Access Compliance Report

Public Rights-of-Way

(Curb Ramps)

Intersection ID: 15242	Main Street: E_INDEPENDENCE_BV	Cross Street: N_WENDOVER_RD_RA	Location: SW
ADA ID: 2C2702BB26FF	Ramp Type: Perp	Initial Pass/Fail: Fail	Overall Compliance: No
Severity Score: 21.25			
Codes/Mitigation Info/Possible Solution		Field Measurements/Component Compliance

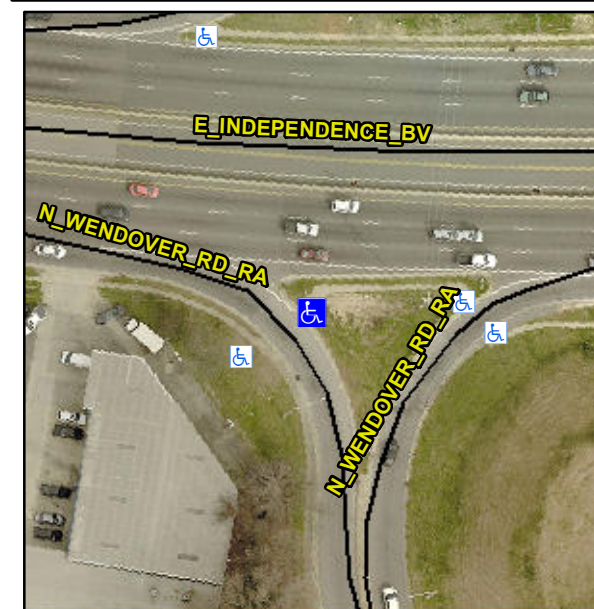
Not Found, R304.5.1, R304.2.2

Compliance	Description	Data	Compliance	Description	Data
N/A	Ramp Length (in)	65.0	No	Ramp Slope (%)	9.3
No	Ramp Width (in)	42.0	Yes	Ramp XSlope (%)	2.0
N/A	Flare Type LT	N/A	N/A	Flare Type RT	N/A
N/A	Flare Slope LT (%)	N/A	N/A	Flare Slope RT (%)	N/A
N/A	Flare Traversable LT?	N/A	N/A	Flare Traversable RT?	N/A
N/A	Landing Length (in)	N/A	N/A	DWS Provided?	N/A
N/A	Landing Width (in)	N/A	N/A	DWS Contrast?	N/A
N/A	Landing Slope (%)	N/A	N/A	DWS Length (in)	N/A
N/A	Landing X Slope (%)	N/A	N/A	DWS Full Width?	N/A
N/A	Landing Curb? (Y/N)	N/A	N/A	DWS Offset (in)	N/A
N/A	Shared Landing?	N/A			
N/A	Gutter Ponding?	N/A	N/A	Gutter Slope (%)	N/A
N/A	Gutter Lip Ht (in)	N/A	N/A	Gutter X Slope (%)	N/A
N/A	Painted X Walk1?	No	N/A	Painted X Walk2?	N/A
	X Walk 1 Direction	To S		X Walk 2 Direction	N/A
N/A	X Walk 1 Width (in)	N/A	N/A	X Walk 2 Width (in)	N/A
	X Walk 1 Slope (%)	6.3		X Walk 2 Slope (%)	N/A
	X Walk 1 X Slope (%)	1.8		X Walk 2 X Slope (%)	N/A

Remove & Replace Entire Ramp.
